ENVIRONMENTAL PROTECTION AGENCY

40 CFR Part 63

National Emission Standards for Hazardous Air Pollutants for Source Category: Pulp and Paper Production

ACTION: Proposed rule amendments and notice of public hearing.

Figure 1. Proposed Changes to Daily Monitoring Requirements for Open Biological Treatment Systems

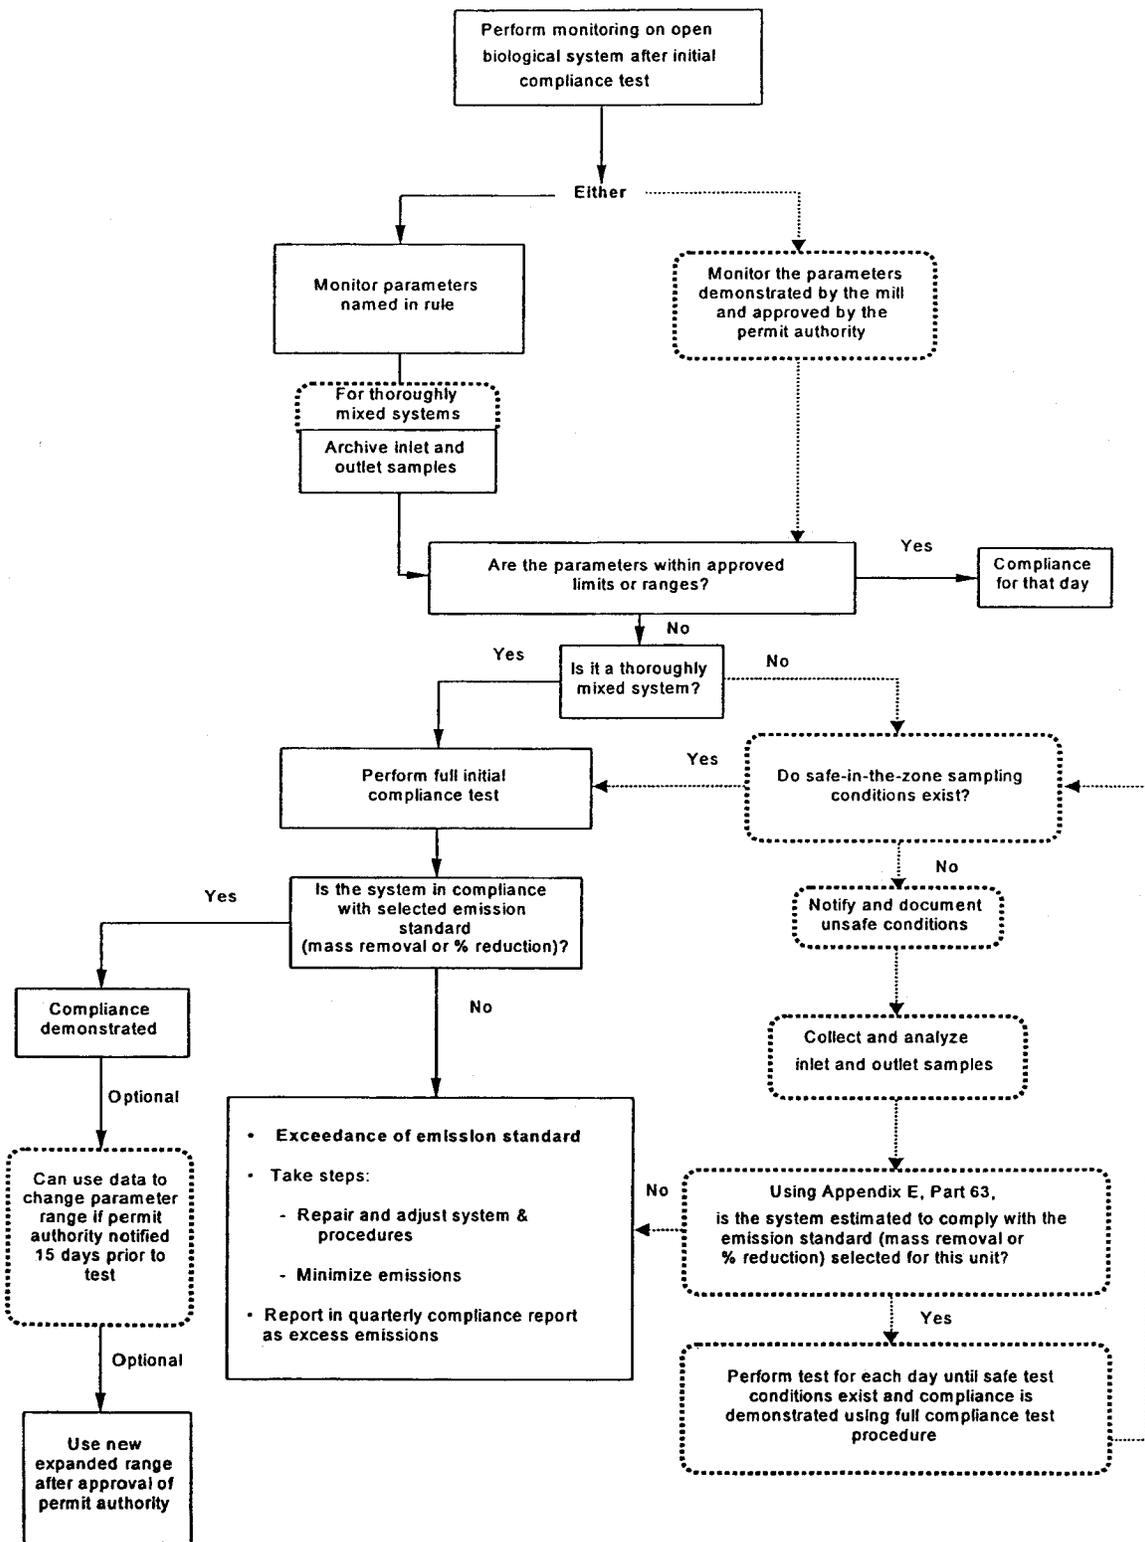
The flow diagram shown in figure 1 summarizes the daily monitoring

requirements for open biological treatment systems. In figure 1, today's proposed changes are depicted by dashed lines and rounded boxes.

(Dotted lines denote proposed changes)

Mills must monitor on a daily basis either the parameters specified in the final rule (§ 63.453(j)(1)) or site-specific parameters that have been approved (proposed § 63.453(j)(2), see section I.E.2 of this preamble). If the monitoring parameters are within the values or ranges established during the initial performance test, compliance with the applicable emission standard is demonstrated for that day. If the monitoring parameters are outside the established values or ranges, you must conduct a performance test to confirm compliance of the open biological treatment system. The performance test must be performed using the same procedures (*i.e.*, the appropriate procedures in appendix C of part 63) that were followed during the initial performance test.
